PRODUCT SAFETY RECALL

SUBJECT: Safety Belt Buckle Anchor Fracture

MODELS: 2011 Cadillac SRX
2011 Chevrolet Equinox
2011 GMC Terrain

2545470

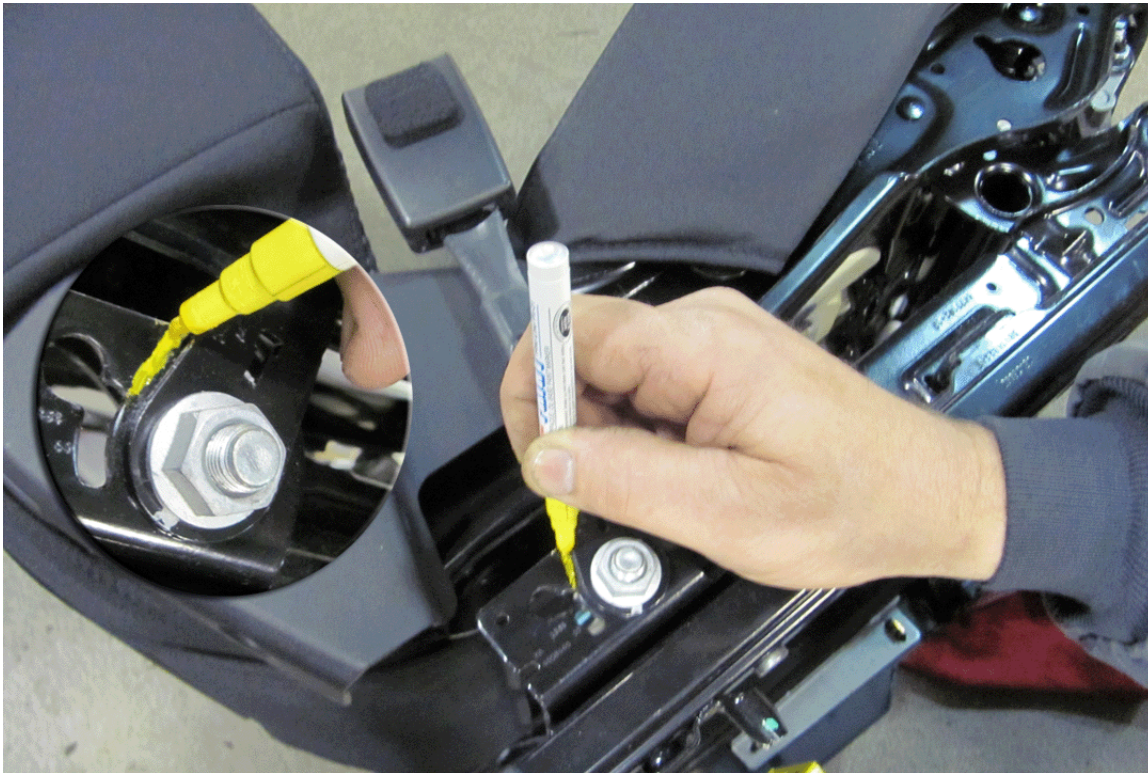
Note: The seat belt buckle assembly angle must be marked with a marker prior to removal so that the seat belt buckle assembly alignment is correct on reassembly.

3. Use a marker to highlight the edge of the seat belt buckle assembly to the seat frame. Refer to illustration.
4. Remove the seat belt buckle assembly and place it on a work bench or vise.

2545472

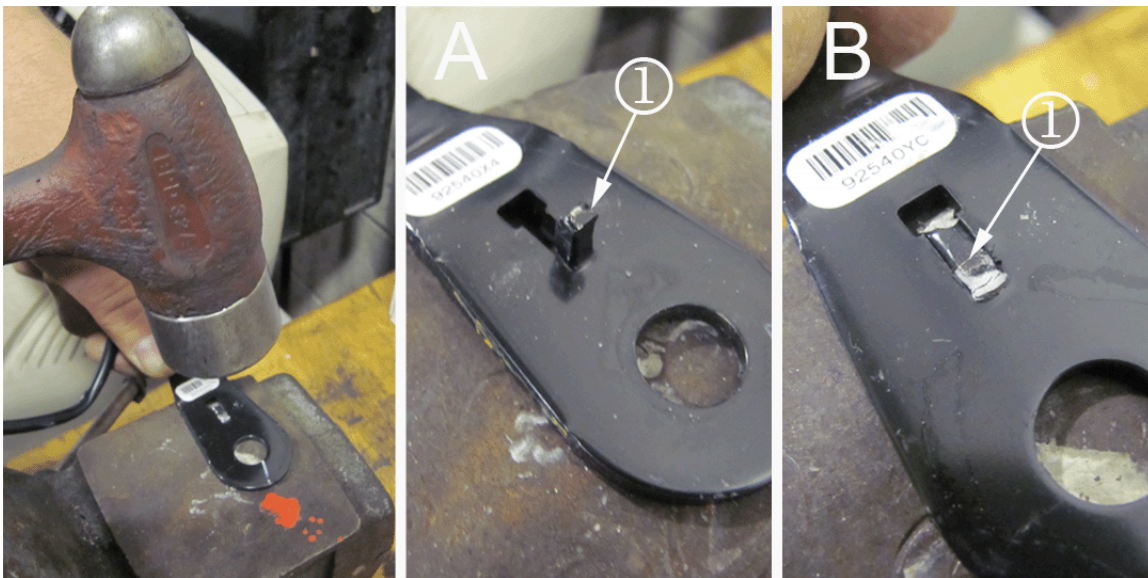
5. Using a hammer, bend the anti-rotation tab (1) on the seat belt buckle assembly. Ensure that the anti-rotation tab is bent down into the tab notch (B). Refer to the illustration.

Note: Use the seat buckle assembly orientation reference mark created in Step 3 to ensure that the seat belt buckle assembly is installed at the correct angle.
